CONSTRUCTION DOCUMENTS REVIEW

RE: QUIZNOS SUB
Zachary Commerce Center, Store #11446
Highway 64 & Highway 964
Zachary, LA 70791
(Accepted 11-17-06)

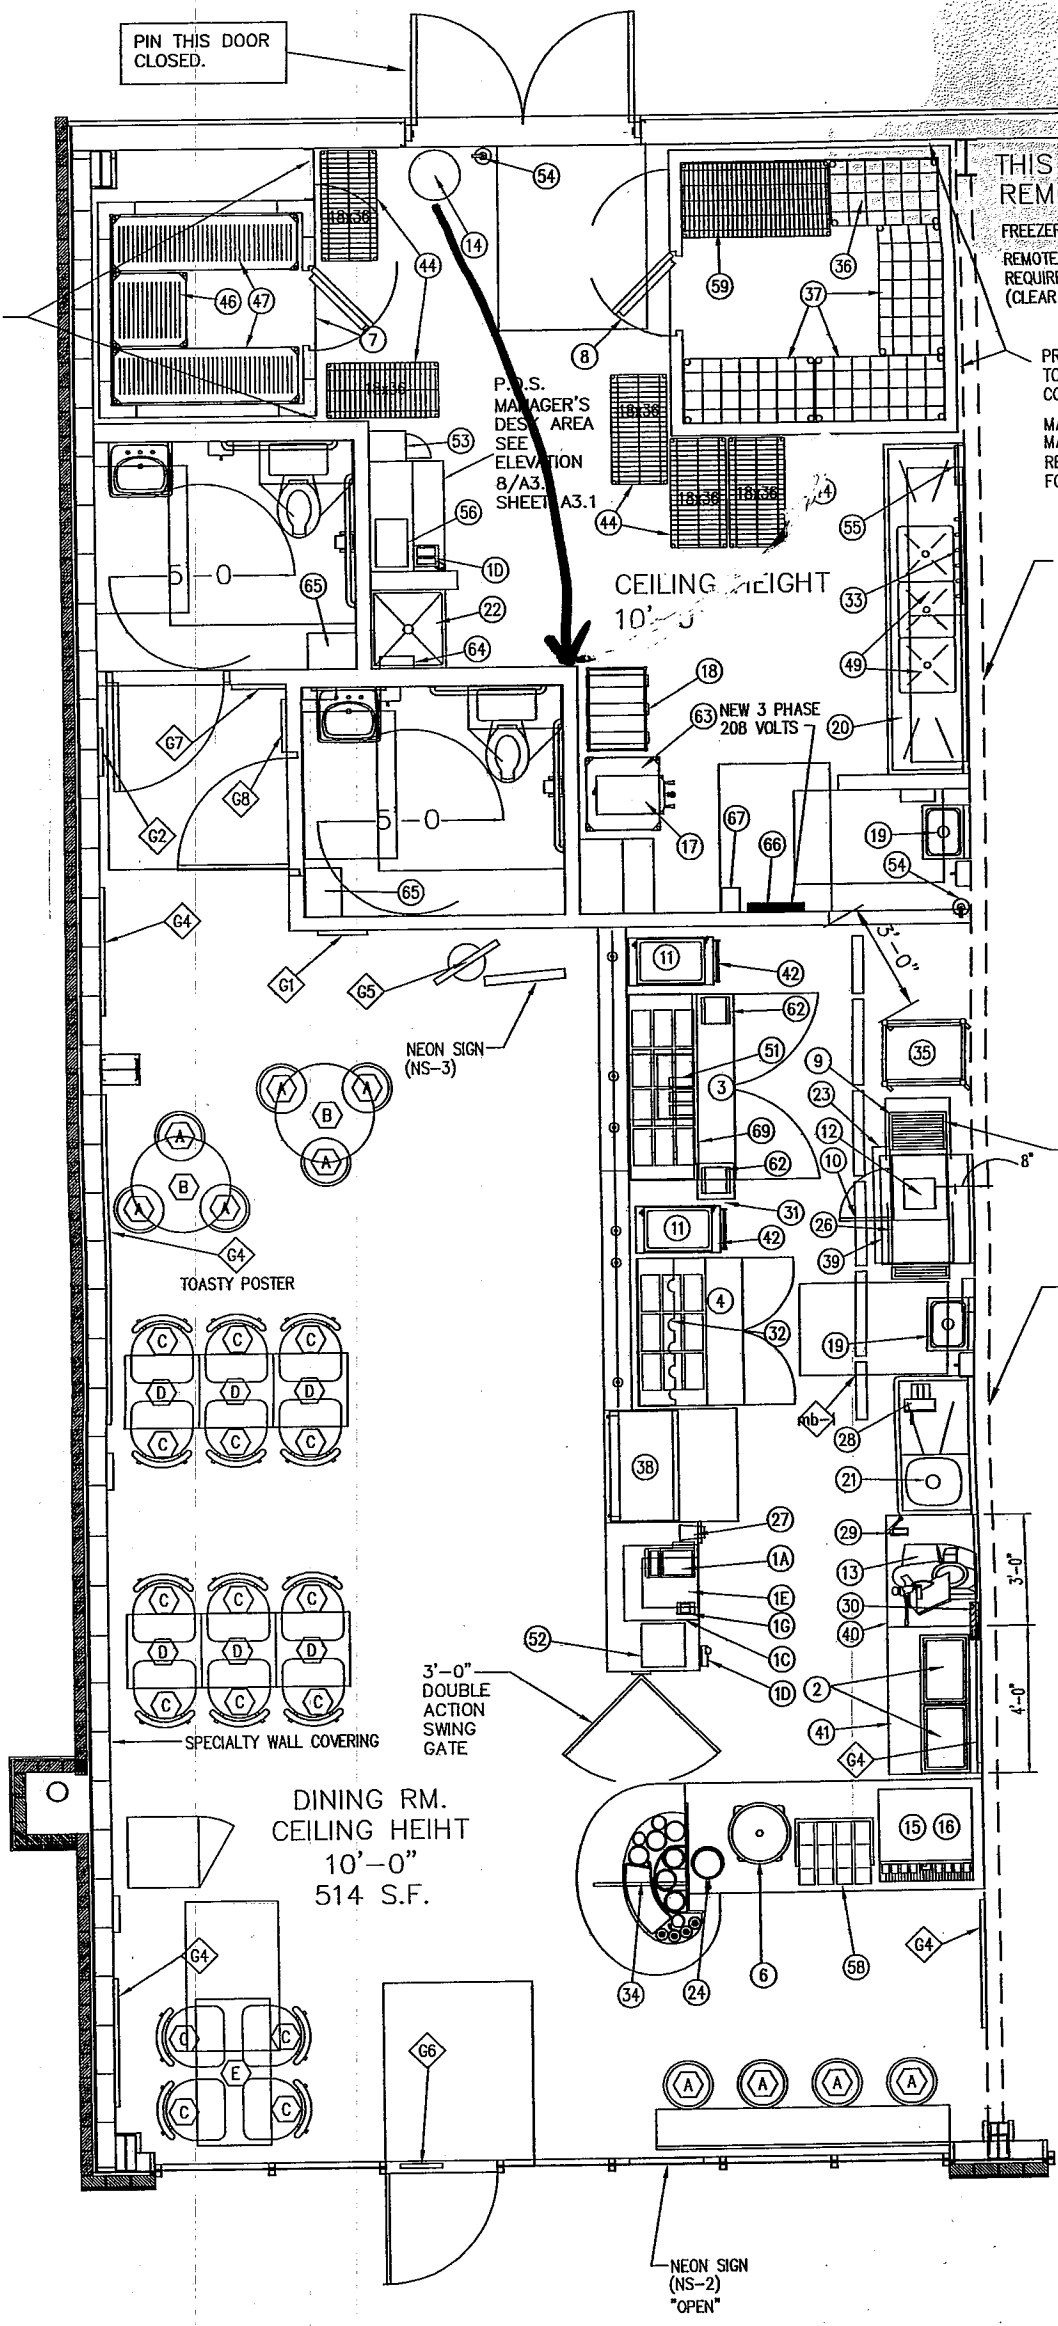
THIS STORE REQUIRES
REMOTE COMPRESSORS

FREEZER HEIGHT IS 9'-6" A.F.F.
REMOTE UNITS
REQUIRE A MINIMUM 10'-0" A.F.F.
(CLEAR SPACE)

TOASTER MUST BE LOCATED
8" AWAY FROM FRP

TOASTER
208V

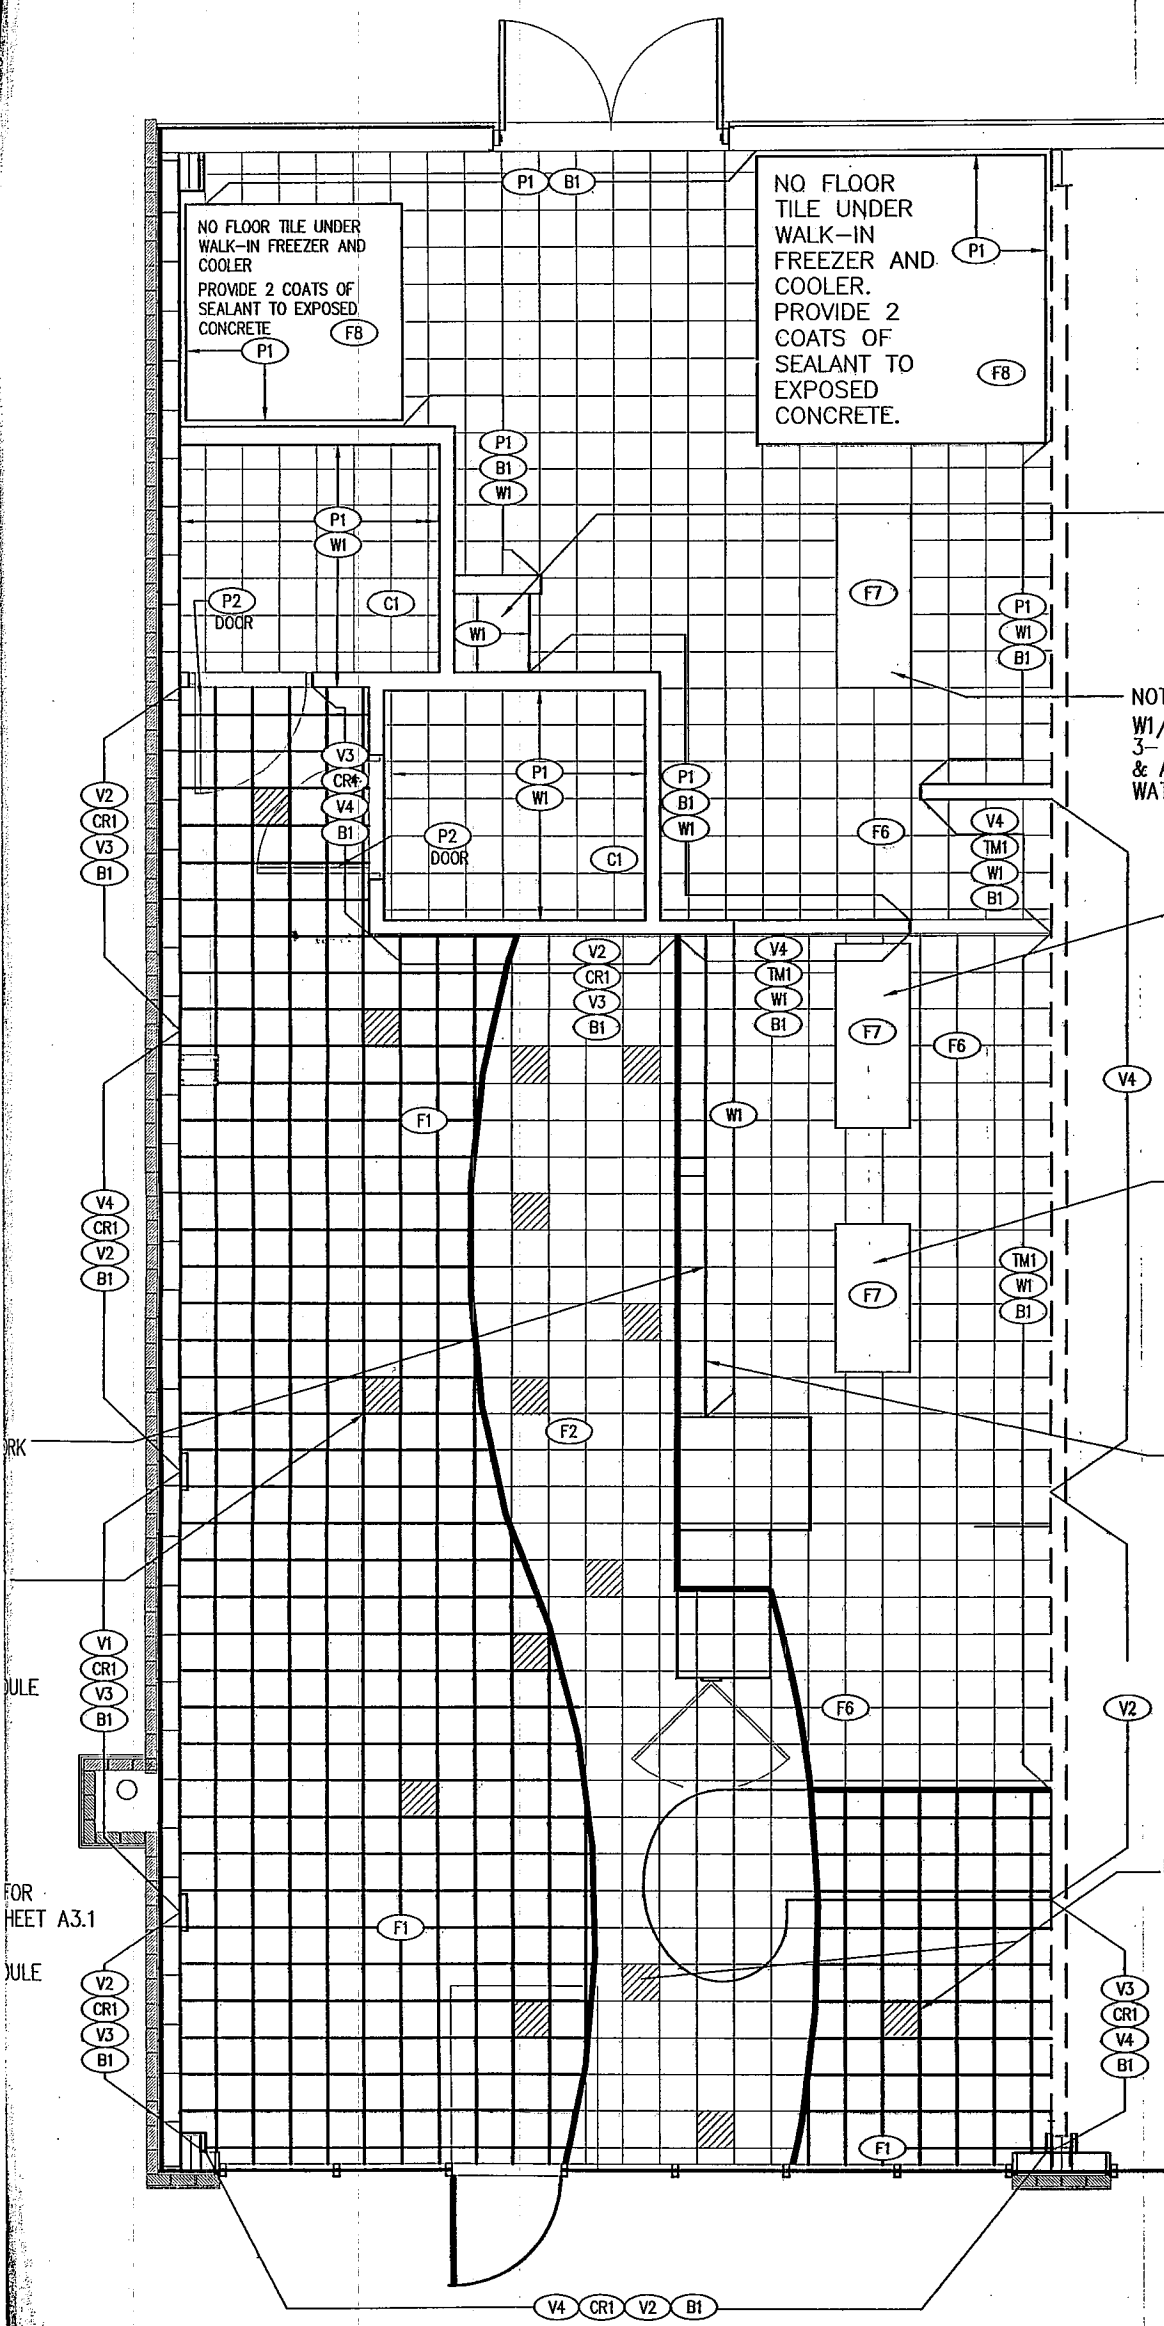
NOTE:
A CLASS II HOOD IS REQUIRED
TO BE INSTALLED ABOVE TOASTER

NO FLOOR TILE UNDER WALK-IN FREEZER AND COOLER. PROVIDE 2 COATS OF SEALANT TO EXPOSED CONCRETE.

INSTALL F7 SLIP RESISTANT VCT @ THIS LOCATION
